DEVELOPMENT DETERMINATION PANEL MEETING

WEDNESDAY 12 JULY 2023

ITEM 3.1	DA2022/1326 - 4 & 6 RAYNER ROAD WHALE BEACH - DEMOLITION WORKS AND CONSTRUCTION OF A DWELLING HOUSE INCLUDING SWIMMING POOL
REPORTING MANAGER	Steve Findlay
TRIM FILE REF	2023/323154
ATTACHMENTS	1 ↓ Assessment Report 2 ↓ Site Plan and Elevations

DEVELOPMENT APPLICATION ASSESSMENT REPORT

Figure 1 - Approximate area of 10mm non-compliance with southern side setback.

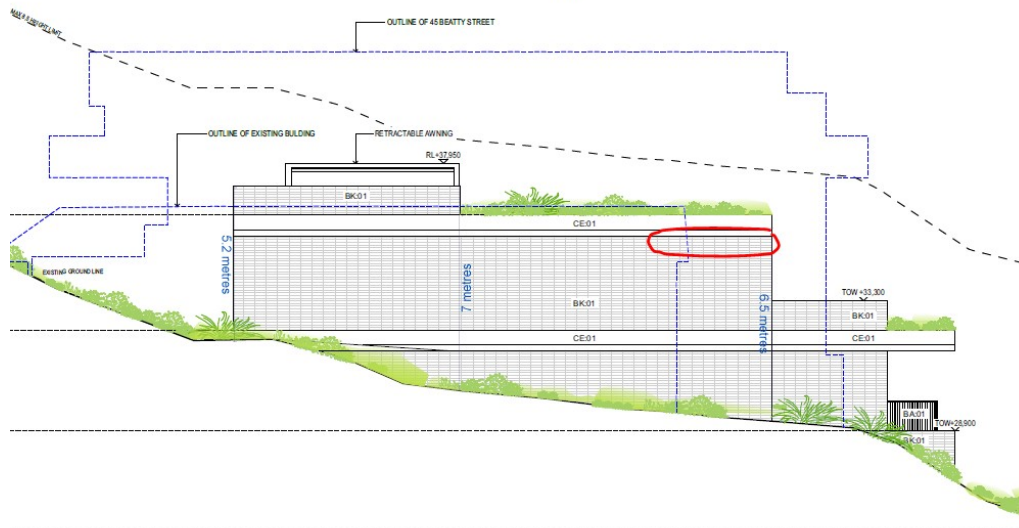
The proposal has a minor breach of the side setback for a minor portion of the southern façade. The control requires 2.1m for a wall height of 6.5, with the proposal providing a consistent 2m setback for the entire southern façade. The vast majority of the southern façade is compliant.

Figure 1: Extract of MLEP 2013 Map (FSR_004, "B" = 0.4:1)

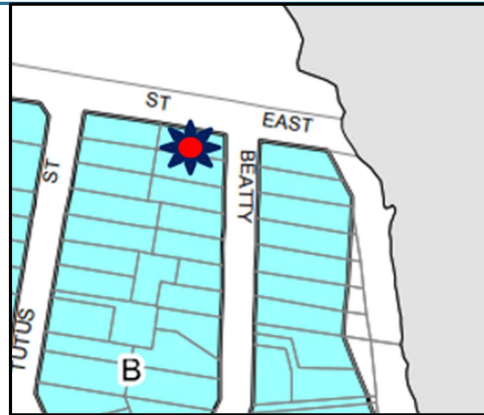
The Floor Space Ratio Map designates a maximum FSR of 0.4:1 for the Site (see Figure 1).

Figure 2: Extract of FSR drawing no. A2401 (Rev DA02- 30.5.23)

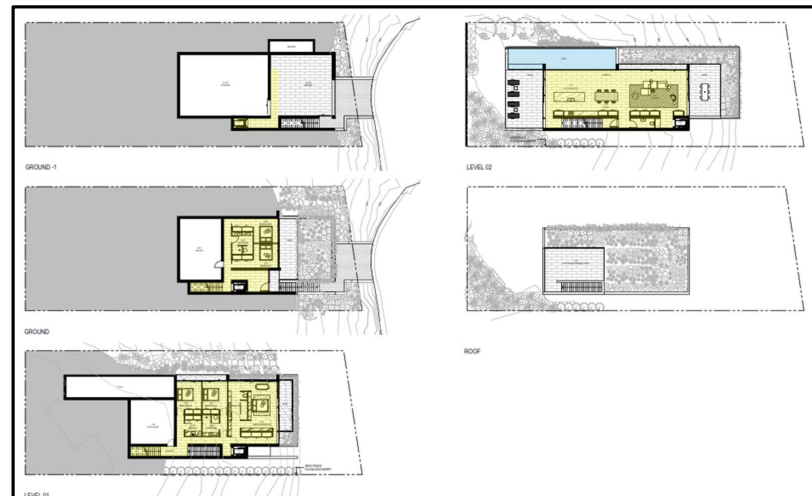
The proposed dwelling house has a gross floor area of 298m², equating to a maximum floor space ratio of **0.47:1**. This is a non-compliance of 47.04m² or 18.7% above the LEP standard.

The following figure outlines the GFA of each floor level - shaded yellow and the GFA summary for each level:

Figure 4: Beatty Street proposed streetscape and comparison of bulk & scale with neighbouring development (Dwg No. A3103)

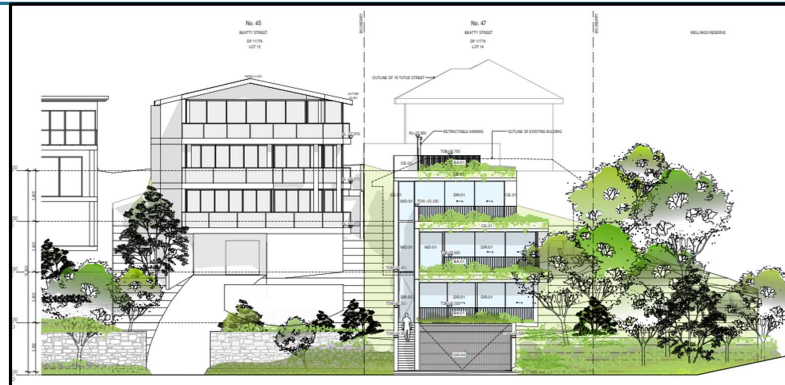
The development presents as a three storey, stepped dwelling to Beatty Street that is connected to the street level, not elevated above it. From the rear and sides it reads as a one – two storey building. It is subordinate to the scale and proportions of residences immediately to the south of the site and connected to the reserve to the north, appearing as a modern two storey structure from the bushland (see Figure 6 below).

The visual presentation to Beatty Street is modernised, similar to a number of redeveloped residential sites along the street and within this section of Balgowlah Heights and the Reef Bay foreshore area. (see Figure 5 above). The proposal does not seek to intrude into the streetscape, rather retaining a subordinate scale when compared with other residential development to the south. The front setback was essentially supported at pre-DA as it is consistent with buildings in the direct locality.
